Dear Members of the ZBA,

In advance of Monday's final ZBA hearing on the Villages at Sudbury Station we would like to submit this comprehensive overview of community and citizen concerns. These remarks have been sourced from the many concerned citizens following the Sudbury Station project.

New Traffic Scenario: 1

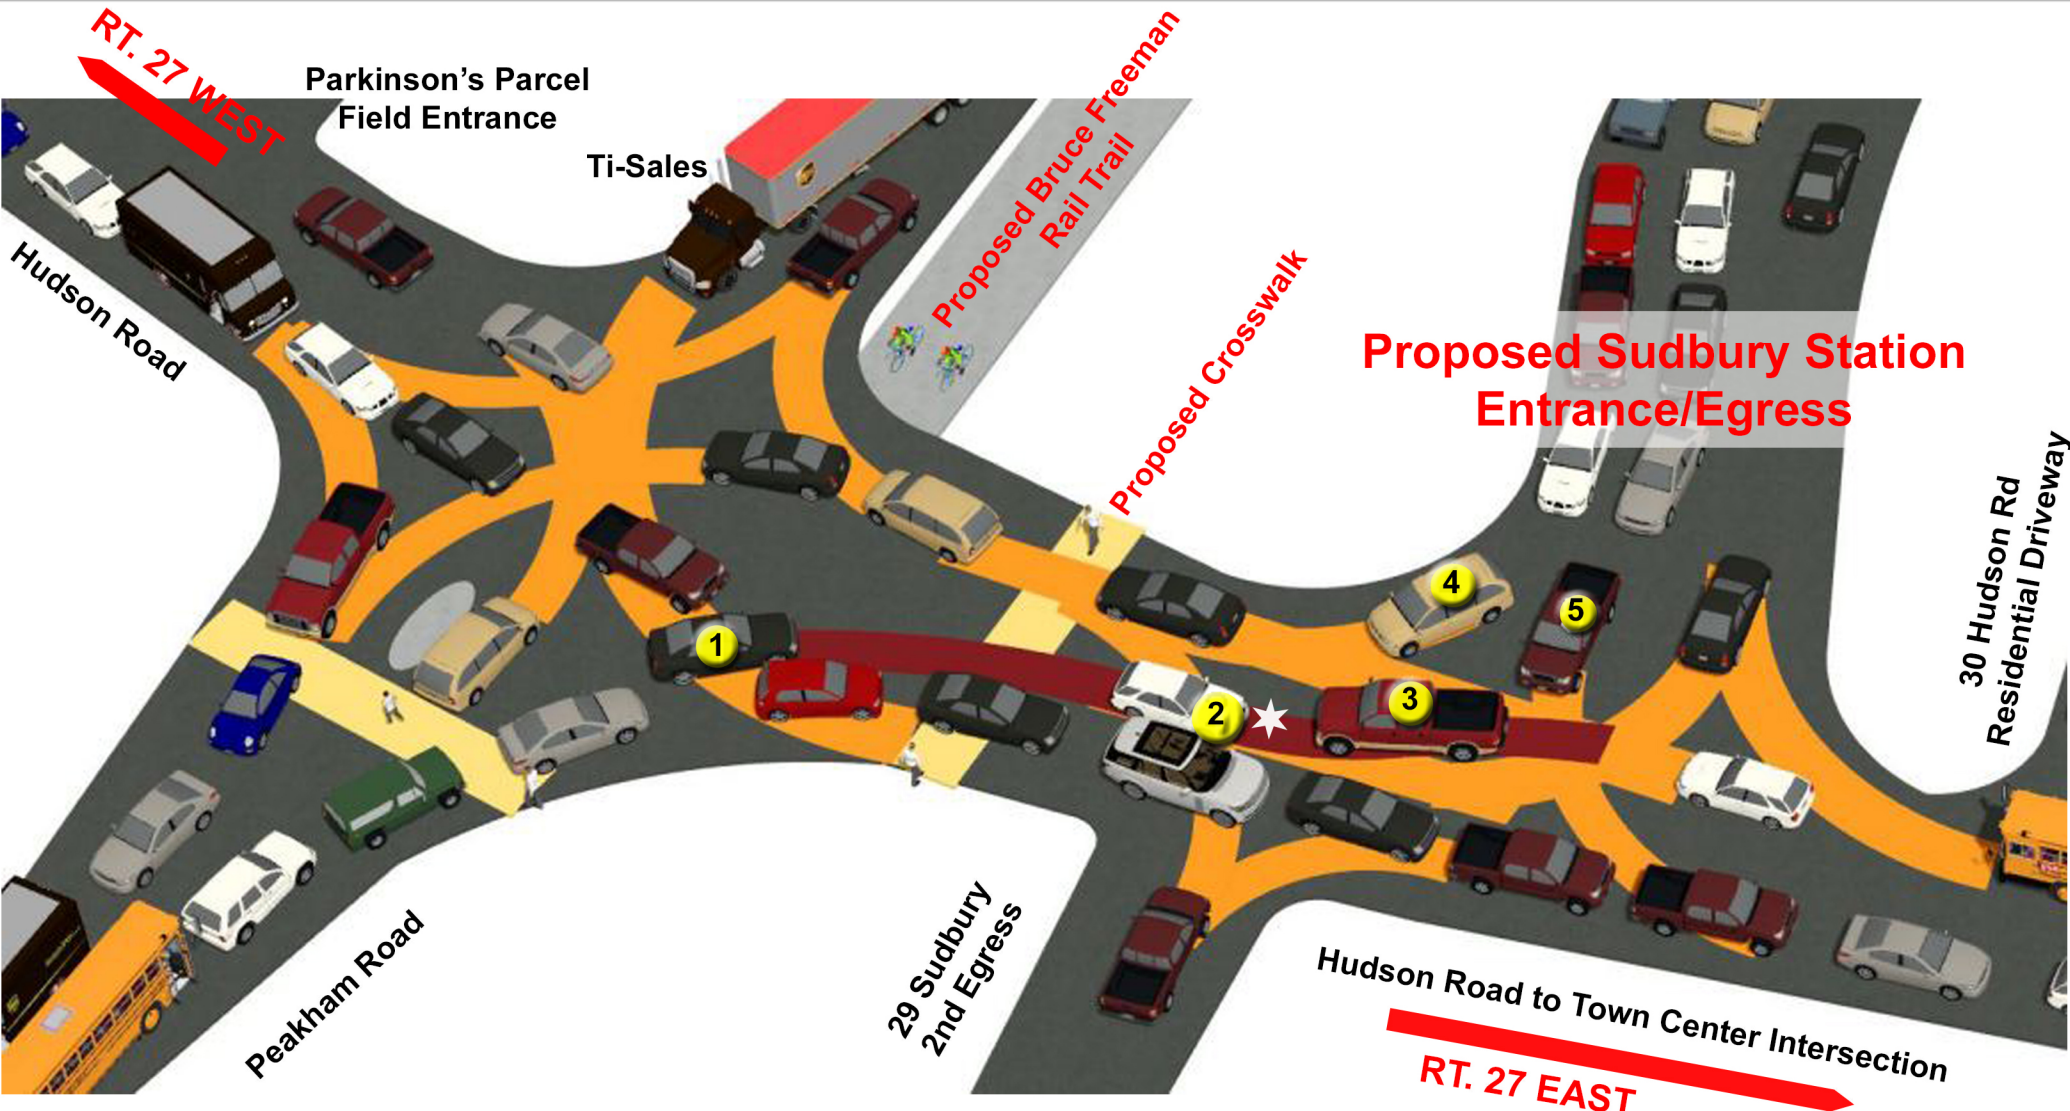
Vehicle 4 turning west out of the proposed Village at Sudbury Station, pulls forward beyond Vehicle 5 to see westbound cars on Hudson Road. Vehicle 3 coming west from the town center intersection swerves towards the double center line to avoid vehicles 4 and 5. Vehicles 1 and 2 turn east from Peakham Road to Hudson Road and cross double center line to pass queued cars in order to turn left at the town center intersection. The left turning lane at the town center intersection begins to the east at 18 Hudson Rd. **Vehicles 2 and 3 collide.**

New Traffic Scenario: 2

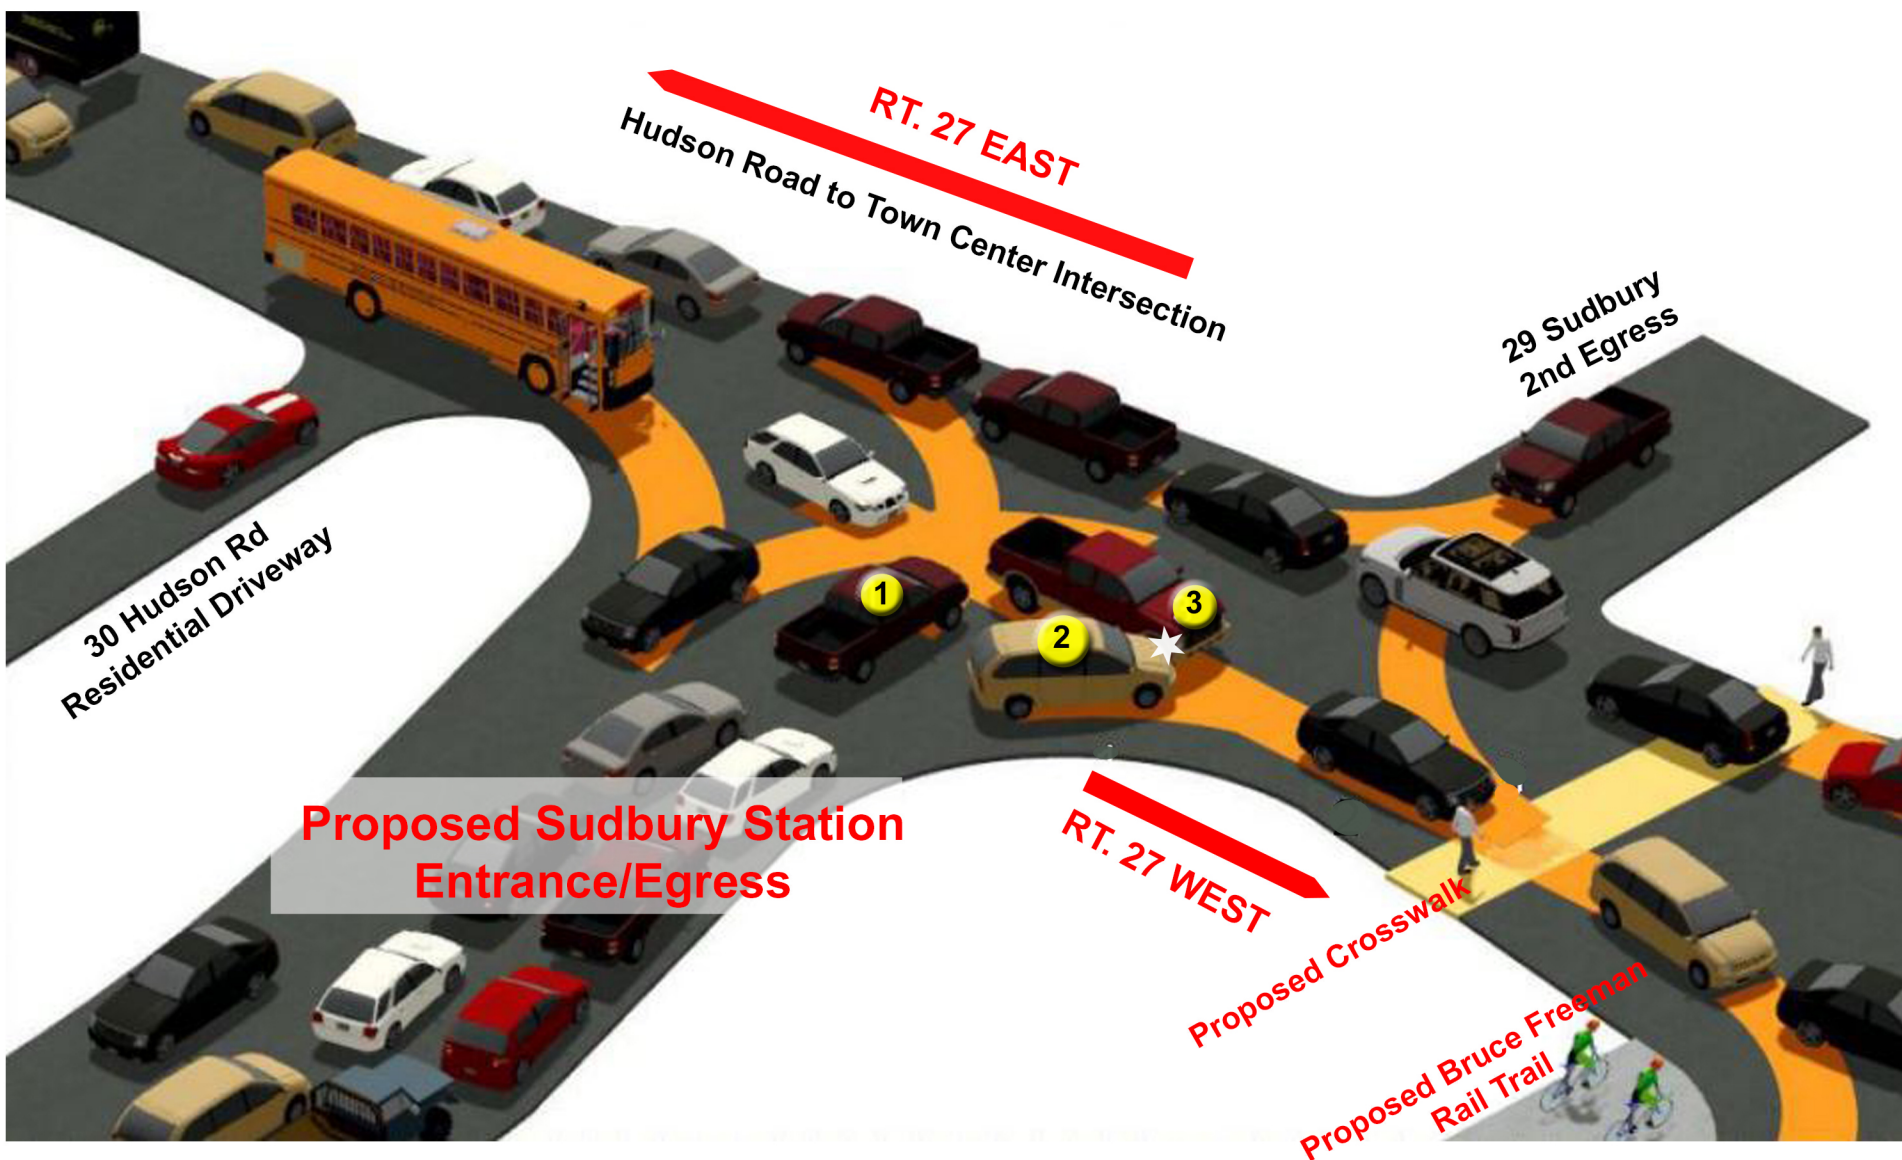
Vehicle 2 heading west out of the proposed Village at Sudbury Station, pulls forward beyond Vehicle 1 to see westbound vehicles on Hudson Road.
Vehicle 2 collides with Vehicle 3 (view of Vehicle 3 is blocked by Vehicle 1).

New Traffic Scenario: 3

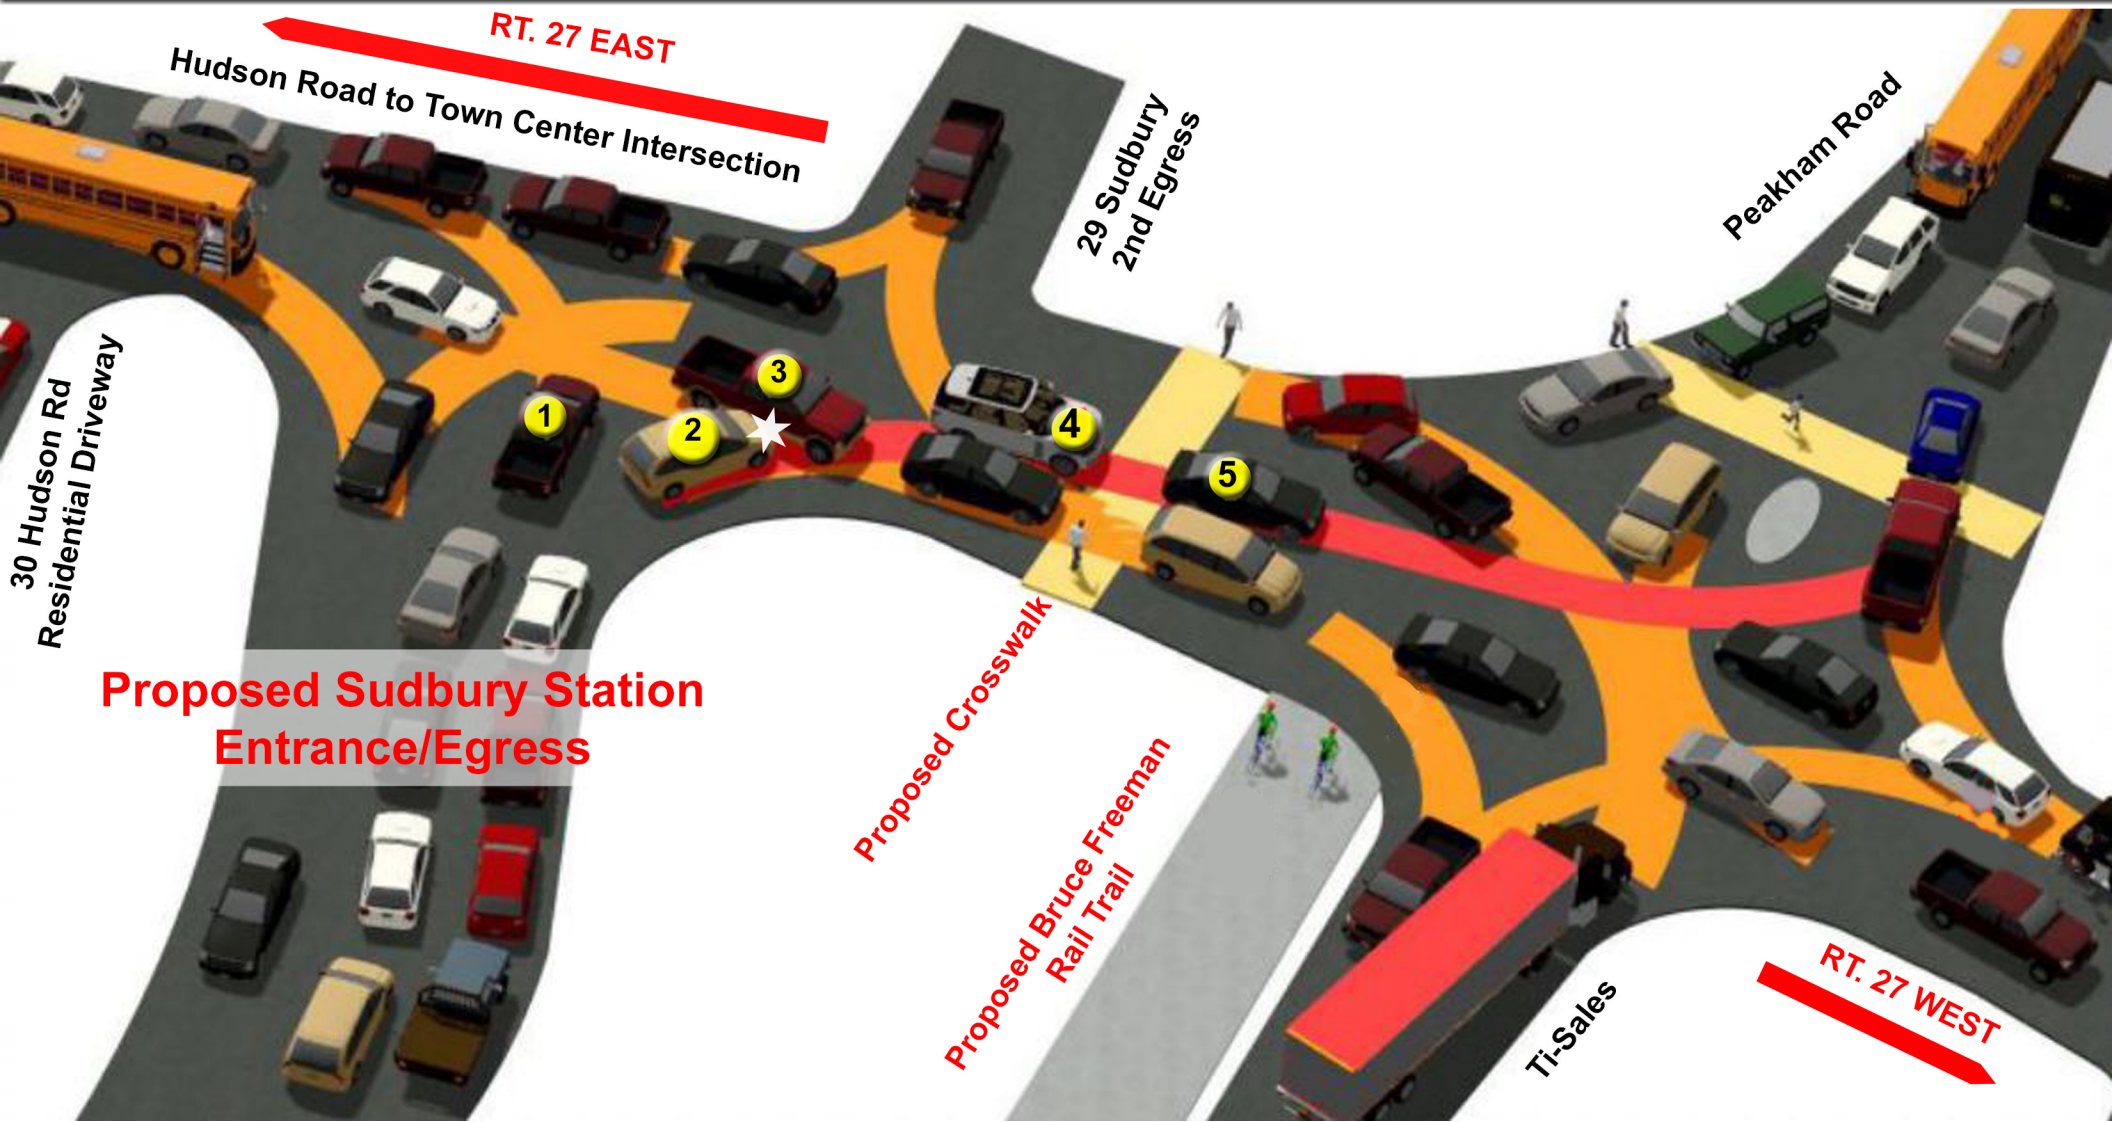
Vehicle 4 and 5 turn right (west) out of the proposed Village at Sudbury Station development. They then want to turn left (south) on to Peakham Rd. These vehicles occupy the center of Hudson Rd as shown in red and cross the double center line into the east bound lane. Vehicle 3, which is driving west from the town center intersection, veers to right to continue westbound on Hudson Road and to avoid Vehicle 4 and 5 which are turning left on to Peakham Road.

Vehicle 2 turns right, collides with Vehicle 3. Vehicle 2's view is blocked by Vehicle 1 which has pulled forward to turn left on to Hudson Road.

New Traffic Scenario: 4

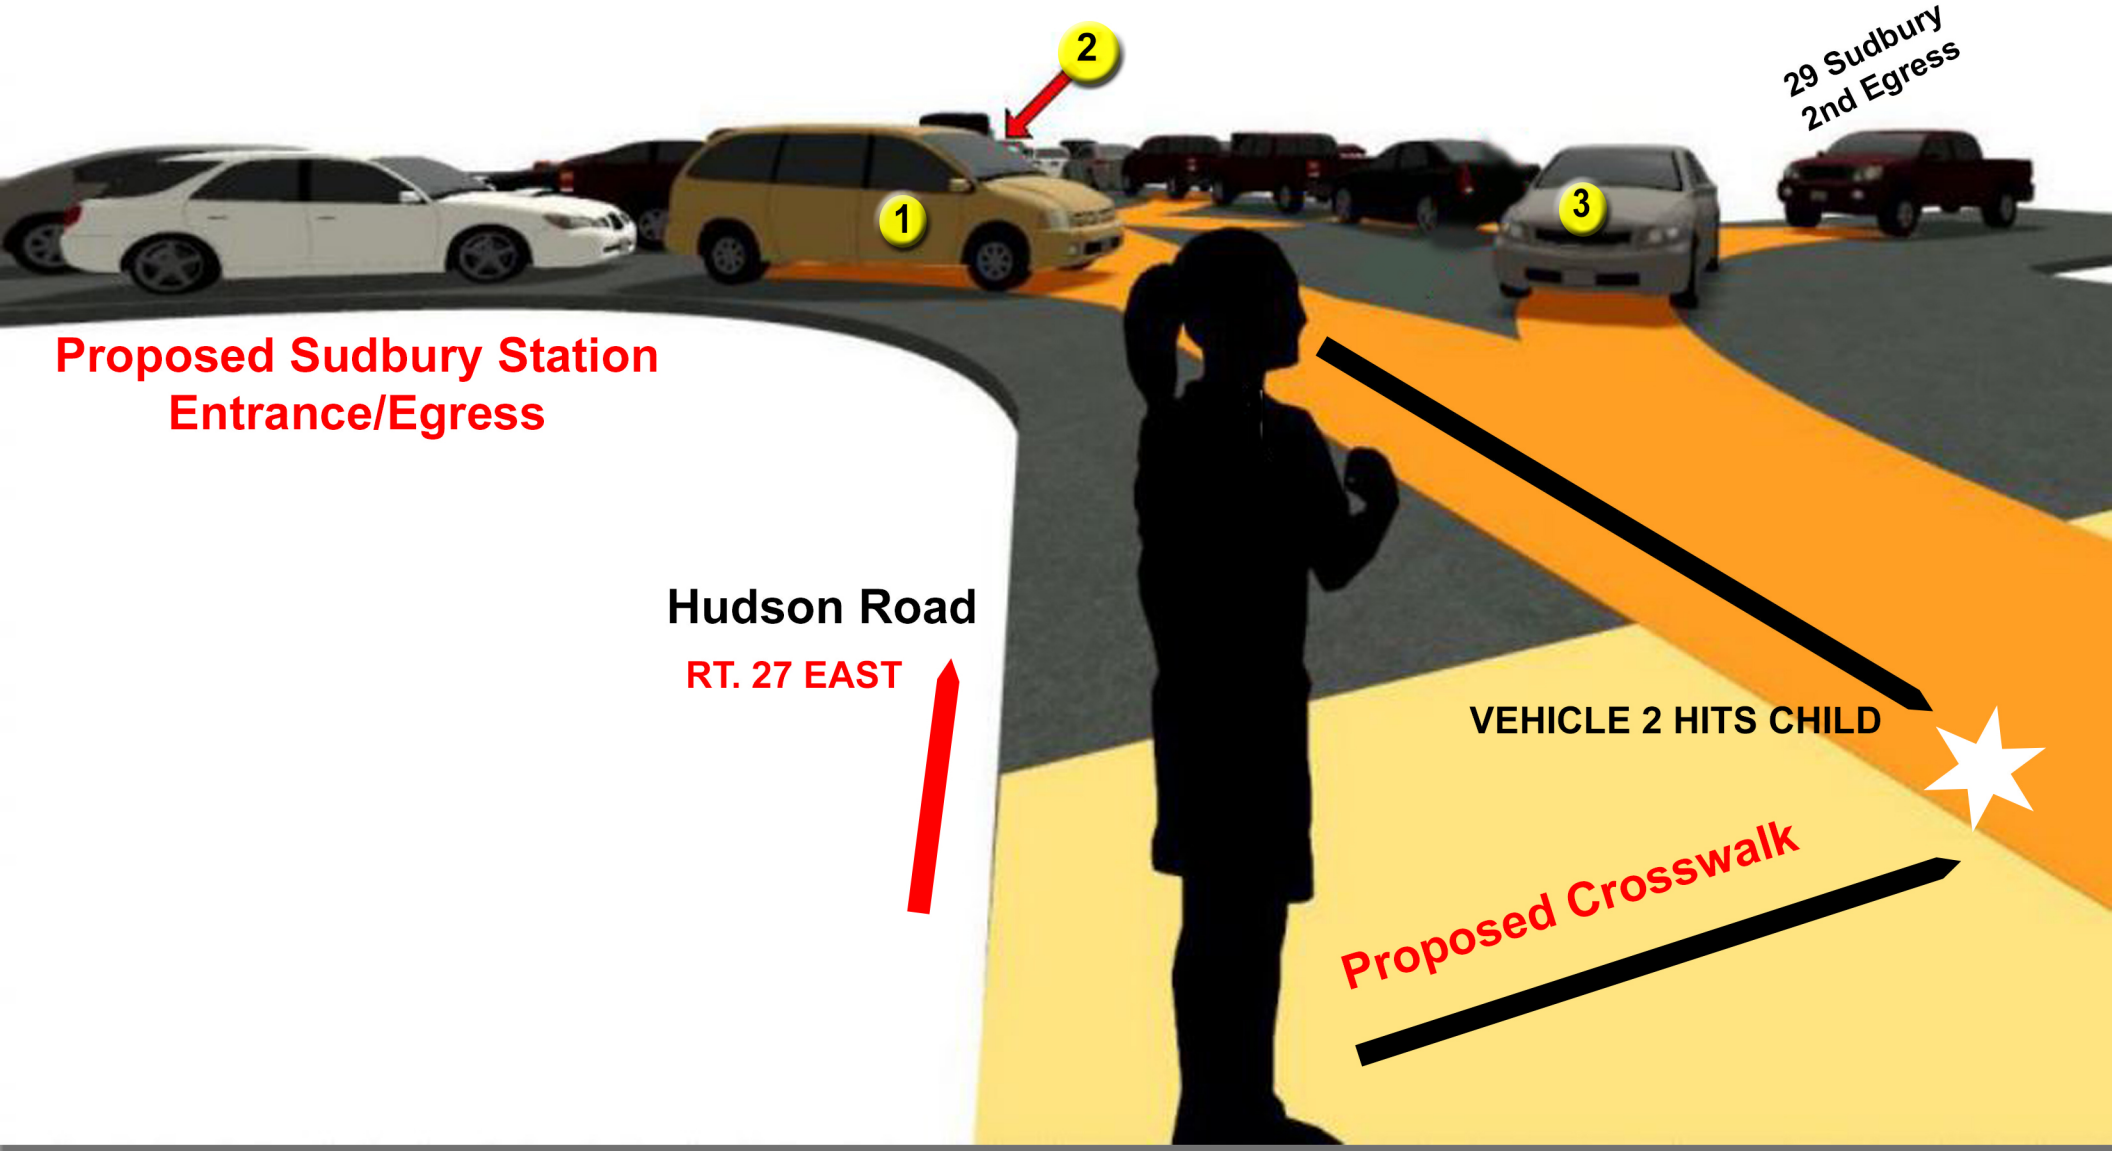
Child in proposed crosswalk crosses Hudson Road heading south. She sees Vehicle 1 and 3, but does not see Vehicle 2 heading westbound at 35 MPH.
Vehicle 2 will reach her in 1.5 seconds.
